Beaver Valley Power Station, Unit No. 2
Docket No. 50-412, License No. NPF-73
Response to Request for Additional Information for License Amendment Request
No. 08-027, Unit 2 Spent Fuel Pool Rerack (TAC No. ME1079)

ATTACHMENT 1
L-10-235

Response to May 27, 2010 NRC Request for Supplemental Information
Page 1 of 20

Figure 1 – LS-DYNA Model for Cell Wall Buckling Evaluation

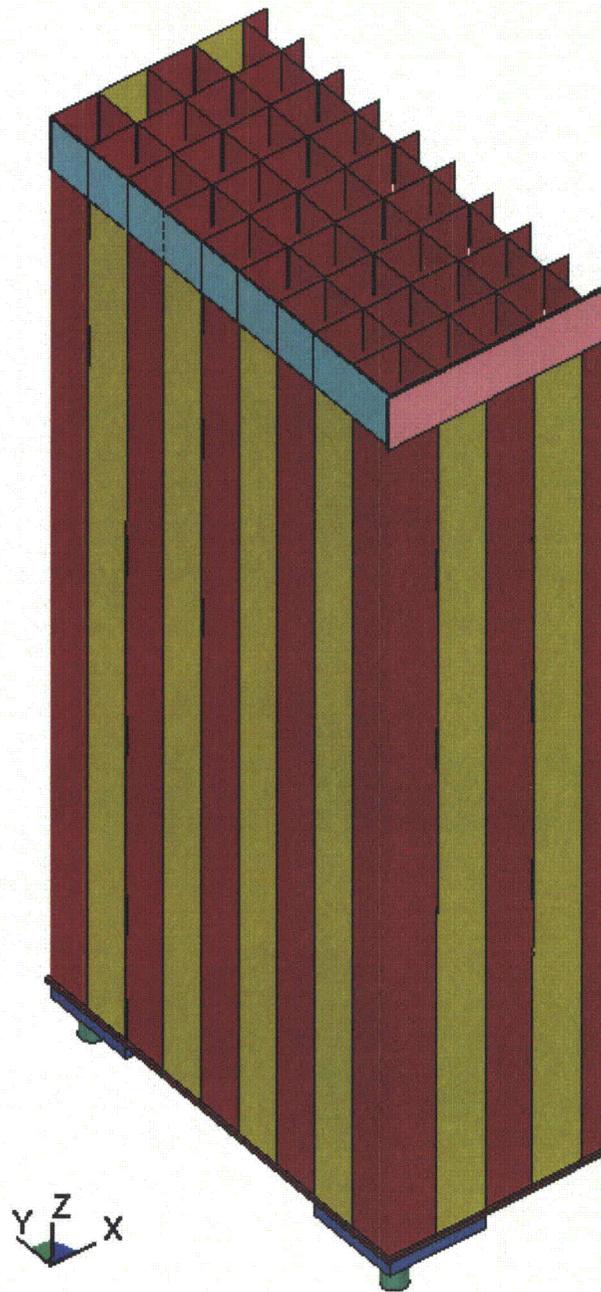
The buckling potential of the cell walls at the top of the rack, which are subject to lateral impact loads, are investigated using the computer code LS-DYNA as described in the response to RAI 11.c in Reference 2. The response to RAI 2.a in Reference 3 incorrectly identified the computer code as ANSYS. This is incorrect since LS-DYNA was the computer code used. LS-DYNA is used, as opposed to a classical plate buckling solution, due to the complex nature of the loading and the boundary conditions. Figure 1 below shows the LS-DYNA model used for this buckling evaluation.

The ½-symmetric model includes all major components of the rack, namely the cell walls, the base plate, the support pedestals, and the reinforcement bars. The model also includes a 10 inch deep by 41.5 inch wide rigid plate (shown in pink in Figure 1), which represents the reinforcement bar on the adjacent rack involved in the impact (referred to hereinafter as rigid impactor). The rack-to-rack impact is simulated in LS-DYNA by applying a pressure time-history on the +y face of the rigid impactor, which is constrained to move only in the y-direction. The peak magnitude of the pressure time-history is arbitrarily set equal to twice the maximum rack-to-rack impact force predicted by DYNARACK under SSE conditions. The duration of the pressure pulse is equal to the duration of the maximum rack-to-rack impact from the DYNARACK simulation. The side of the rack opposite the rigid impactor is fixed against translation.

Figure 2 – Lateral Displacement of Rigid Impactor from LS-DYNA Solution

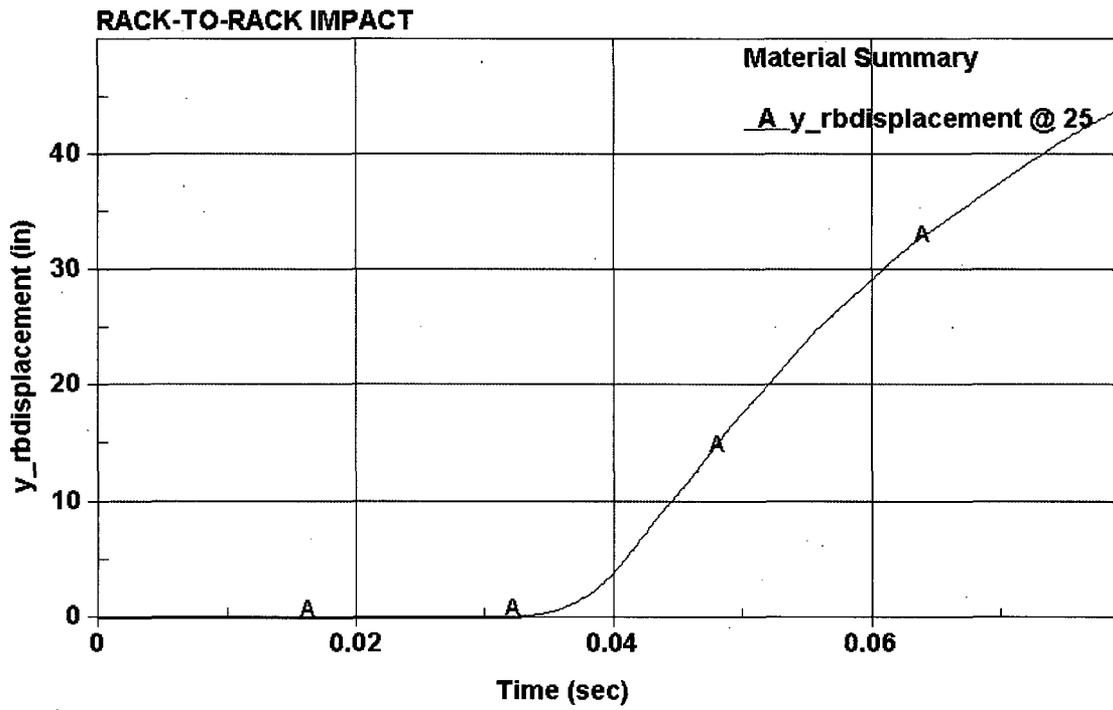
Figure 2 below shows the displacement time-history for the rigid impactor obtained from the LS-DYNA solution. The onset of buckling is marked by the sudden increase in lateral displacement, which occurs at 0.0325 seconds. The corresponding impact load at $t = 0.0325$ seconds is 153.5 thousand pounds-force (kips), which is considered to be the critical buckling load for the spent fuel racks under lateral impact. The maximum rack-to-rack impact load predicted by DYNARACK is only 101.8 kips. Therefore, the safety factor against buckling is:

$$SF = \frac{153.5 \text{ kips}}{101.8 \text{ kips}} = 1.51$$

This satisfies the minimum requirement of 1.5 per paragraph NF-3321.1(b) of the ASME Code.

Figure 17-1: True Stress Strain Curves
(a) Weld; (b) Base Material

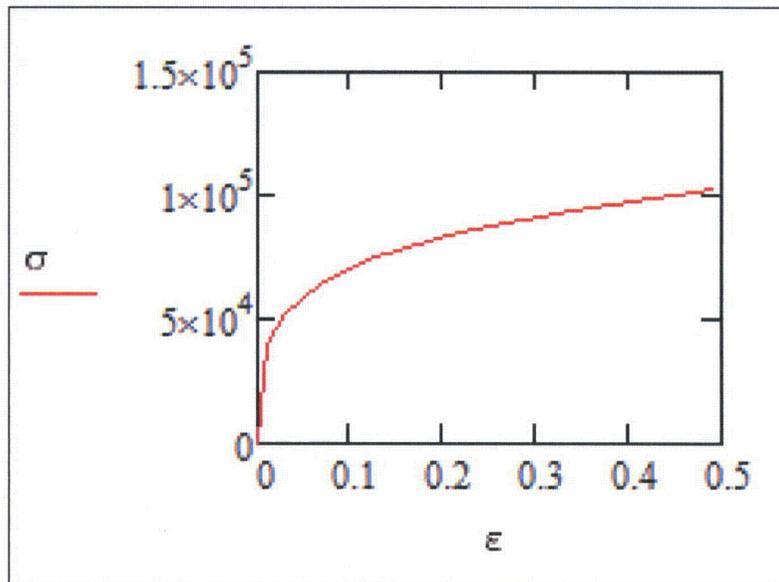
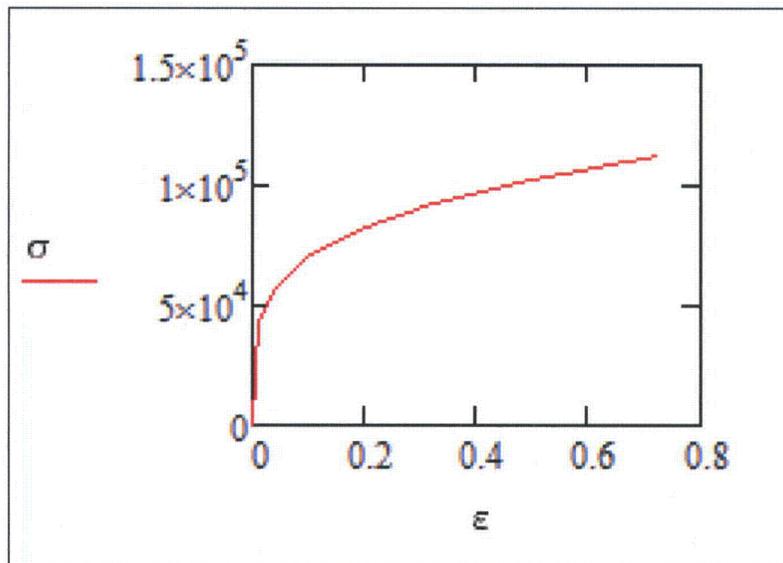
To address the staff's comments/concerns, the shallow fuel drop accident has been re-analyzed using LS-DYNA to incorporate the following changes:

- 1) the stress-strain curve for the weld material is switched from a bi-linear, engineering stress-strain curve to a power law, true stress-strain curve;
- 2) the uni-axial failure strain limits for the base metal (SA-240 304L) and the weld material (Type 308) are the 98 percent exceedance probability failure strain values based on the data provided in Table B.1 of NUREG-1864 (Reference 12);
- 3) a lower bound triaxiality factor is applied to the uni-axial failure strain limits at the start of the simulation;
- 4) a strain rate amplification curve developed from the test data in Reference 13 is applied to both the base metal and the weld material.

Figure 17-1 shows the stress-strain curves for the base metal and the weld material that are input to LS-DYNA for the shallow fuel drop accident analysis. As shown in the figure, the uni-axial failure strain limits for the base metal and the weld material are 0.724 and 0.493, respectively. The uni-axial failure strain limits are calculated according the following relationship:

Figure 17-2: Strain Rate Amplification Curve of the Rack Material

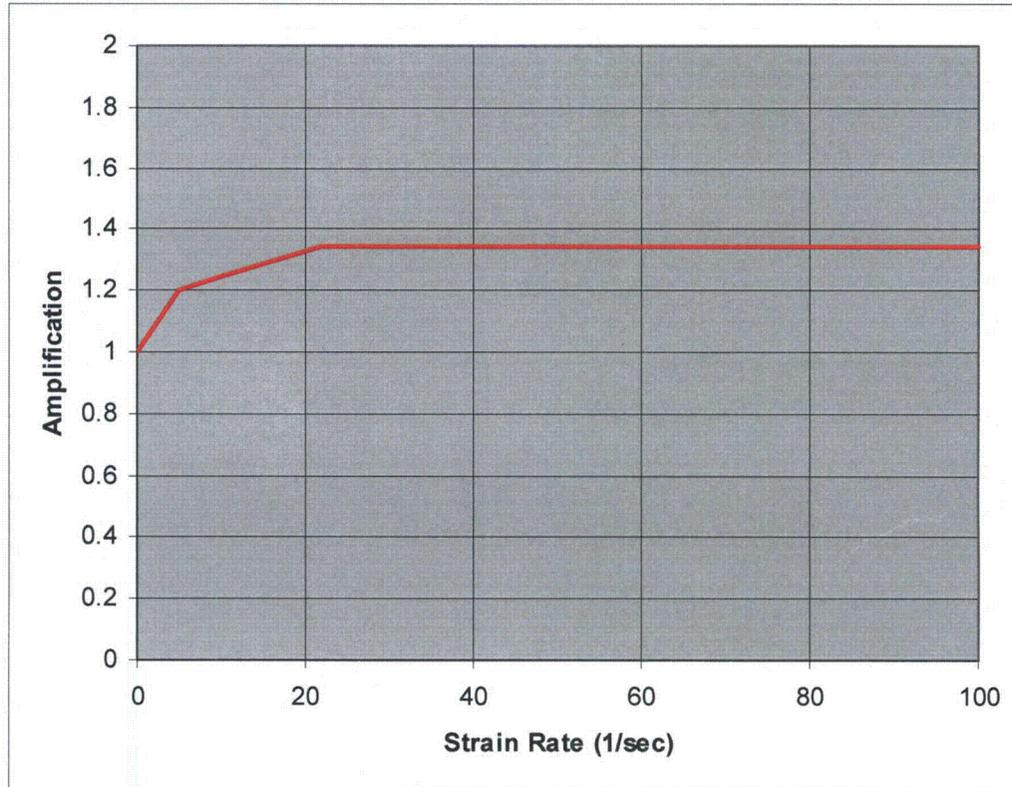
Figure 17-2 shows the strain rate amplification curve assigned to the base metal and the weld material based on the test data in Reference 13. Based on the derivation presented in the response to RAI 17 in Reference 3, a triaxiality factor of 0.6065 is applied to the uni-axial failure strain limits for the base metal and the weld material to bound the worst-possible bi-axial stress state.

Figure 17-3: Impact Force Time History

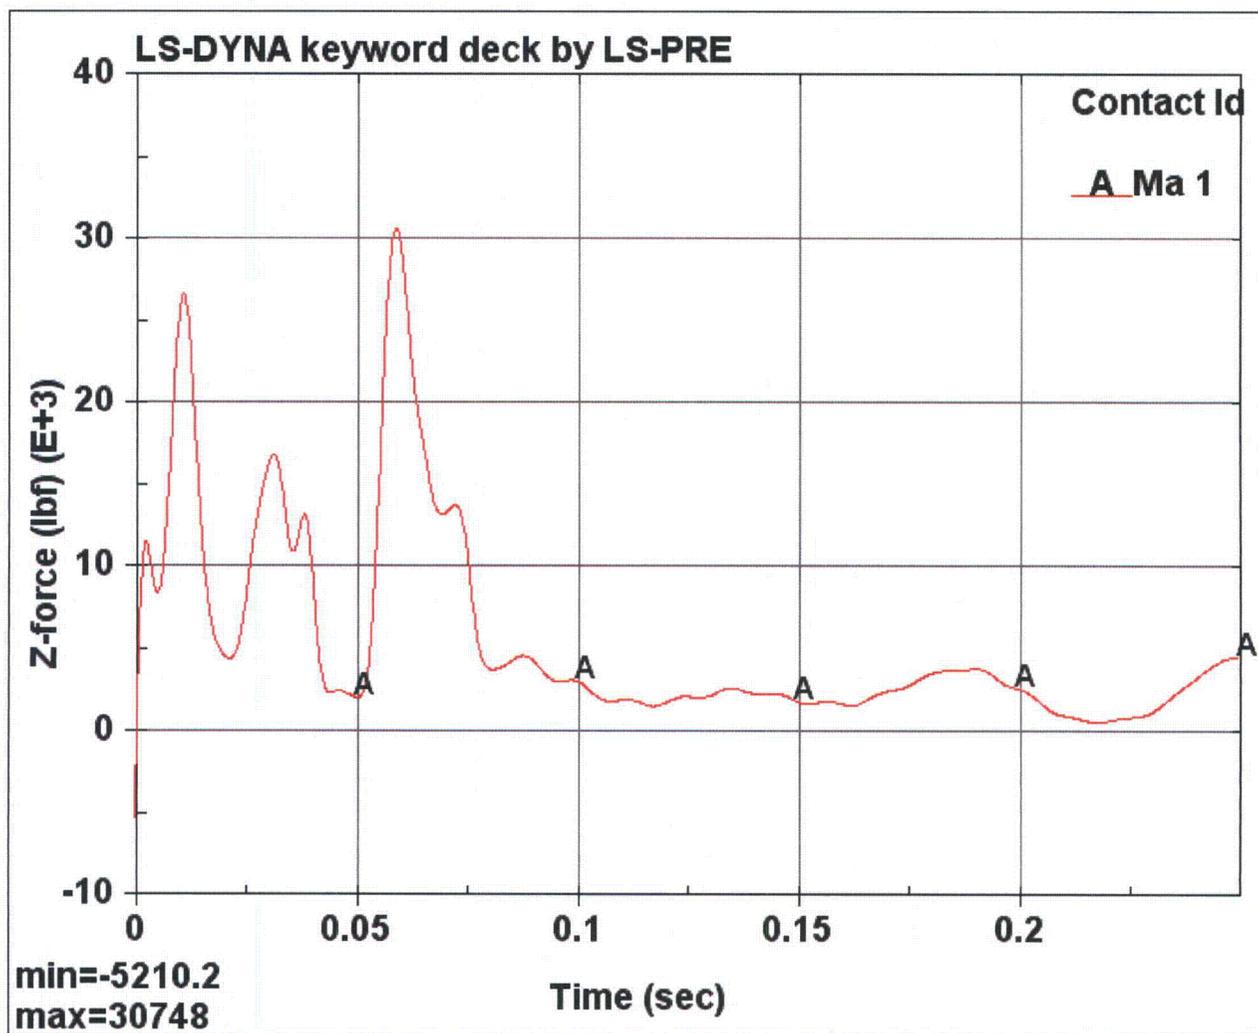
The new results for the shallow fuel drop accident analysis are shown in Figures 17-3 to 17-5 and summarized in the table below.

Shallow Drop LS-DYNA Analysis Results	
Impact Duration (sec)	0.09
Peak Impact Force (lbf)	30,748
Fuel Assembly Vertical Displacement (in)	5.29
Plastic Deformation Measured from the Rack Top (in)	17.92

Figure 17-5: Deformed Shape of the SFP Rack after the Shallow Drop Accident

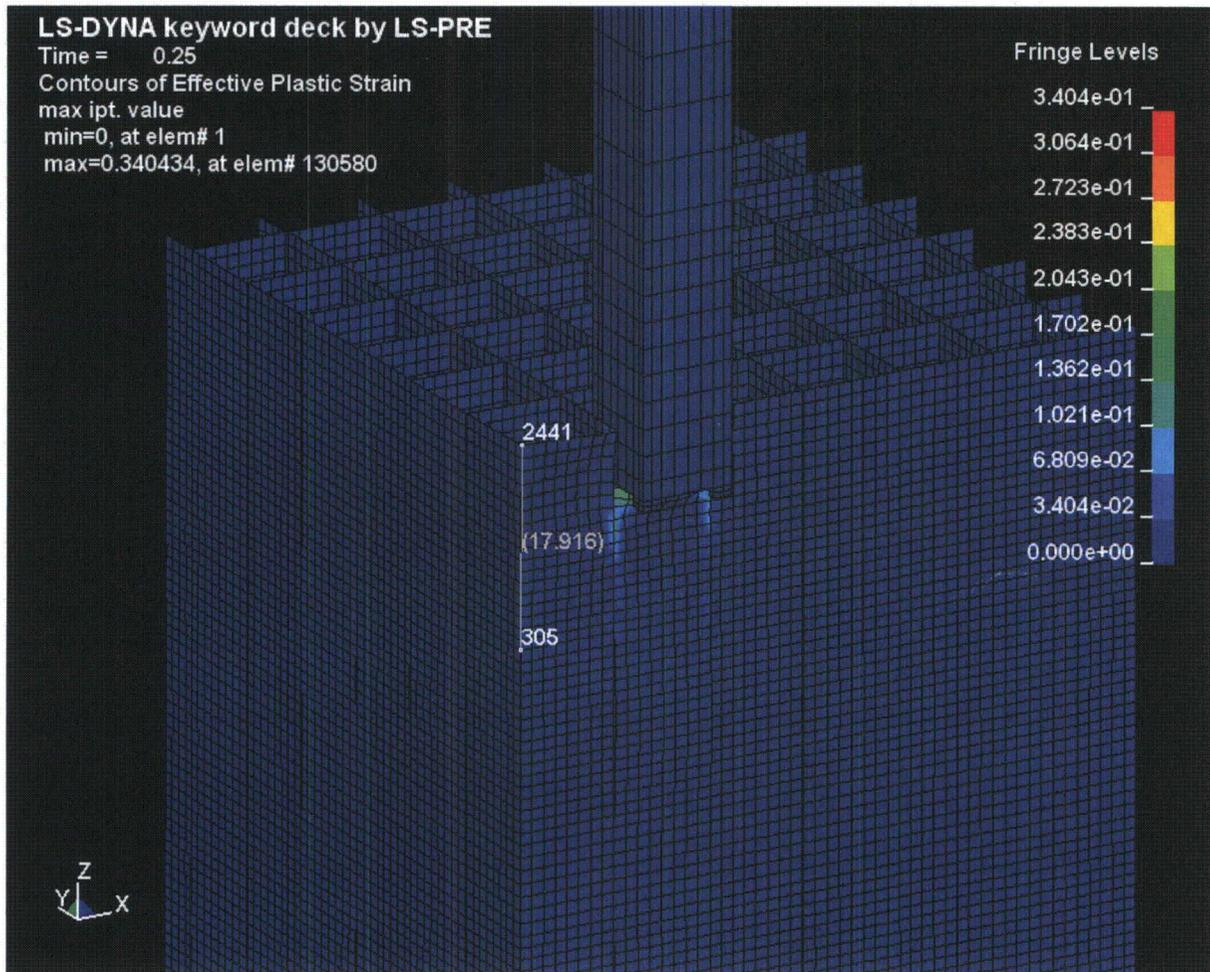
The LS-DYNA analysis results demonstrate that the plastic deformation in the rack cell wall resulting from a shallow drop accident does not extend down into the "neutron absorber zone," which is defined as the vertical length of the cell blanketed by the fixed neutron absorber panel. For the BVPS Unit No. 2 spent fuel racks the minimum distance from the top of the rack to the top edge of the neutron absorber panel (that is, neutron absorber zone) is 19.75 inches. From the LS-DYNA solution, the dropped fuel assembly moves downward crushing the cell wall to a depth of only 5.29 inches, and the plastic strain in the cell wall diminishes to zero at a distance of 17.92 inches below the top of the rack as shown in Figure 17-5. Since the depth of damage by either measure is less than 19.75 inches, the neutron absorber panels do not suffer any damage, and therefore the shallow drop accident has no adverse effect on the criticality safety analysis for the BVPS Unit No. 2 spent fuel racks. In fact, the criticality safety analysis takes no credit for the uppermost 1.3 inches of neutron absorber length, which extends above the active fuel region (assuming the maximum active fuel height and worst-case tolerances). Therefore, taking into consideration the criticality safety analysis, the more precise limit on the permanent deformation to the spent fuel rack due to a shallow drop accident is no greater than 21.05 inches (19.75 inches plus 1.3 inches) measured from the top of the rack. Based on this criterion, the computed safety factor for the shallow drop accident is:

$$SF = \frac{21.05''}{17.92''} = 1.17$$

Figure 19-1: Rack Drop Impact Force Time History

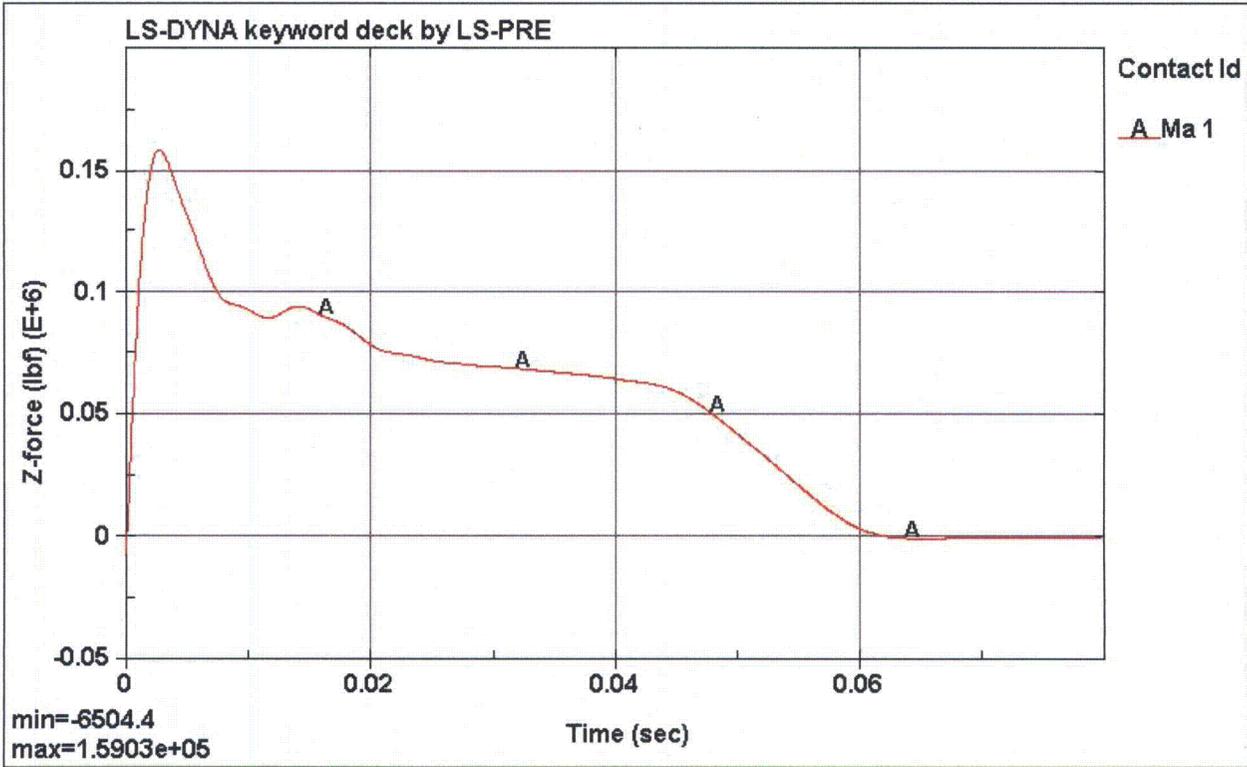
The 4,000 psi concrete compressive strength was used as input only for the rack drop analysis performed in previous revisions of Reference 14. The structural evaluation of the reinforced concrete SFP at BVPS Unit No. 2, under the increased loads from the spent fuel racks, uses the design basis minimum concrete strength of 3,000 psi (Reference 6).

The rack drop analysis has been re-performed using the design basis minimum strength of 3,000 psi. Apart from the change in concrete strength, no other changes to the LS-DYNA simulation model have been made. The results of the re-analysis are summarized below.

The rack drop accident analysis results for 3,000 psi concrete are shown in Figures 19-1 to 19-3 and summarized in the table below. The maximum plastic strain of the SFP floor liner is well below the failure strain of 0.4 for the liner material, indicating that there is no loss of water after the rack drop event. Nevertheless, the SFP floor slab will experience limited local damage as shown in Figure 19-3 due to excessive compressive stress resulting from the impact load at the pedestal/liner interface. In addition, the dropped rack also experiences local plastic deformation in the cells adjacent to the pedestal.

Rack Drop Analysis Results Based on 3,000 psi Concrete	
Impact Duration (seconds)	0.62
Peak Impact Force on the SFP Floor (pounds-force)	1.59×10^5
Maximum Plastic Strain of the SFP Liner	8.82×10^{-3}
Number of Plastically Deformed Cells Near Pedestal	8

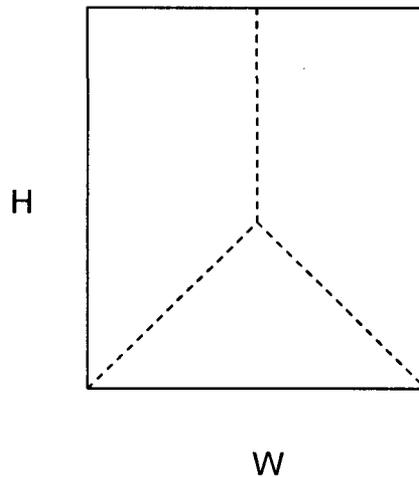
For the one-way shear evaluation, the total shear load on each wall is divided between the vertical edges and the bottom edge based on their tributary area. This means that for a wall of height H and of width W the load is divided as follows:

Bottom Edge: $\beta = \frac{W^2/4}{WH} = \frac{W}{4H}$

Vertical Edge: $\alpha = \frac{1-\beta}{2}$
